## PRODUCT/ PROCESS CHANGE NOTICE

**Number:** 2219-2  
**Date:** 09/26/22  
**From:** Ken Olp  
**ECO#:**  
**ECO Ref.:** (Class: 3 Notification)

**Products Affected:** D53G-020.0M, D53G-026.0M

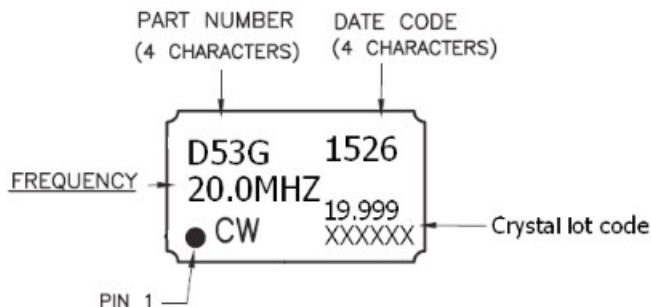
Change design configuration to a smaller TCXO mounted on a ceramic adapter board to achieve the same D53G footprint.

- 1) Due to the smaller size TCXO being thinner, the product height decreases from 2.1mm to 1.4mm.
- 2) Due to the smaller marking area available for part number, date code, and serial number, the format of the marking changes as shown below.
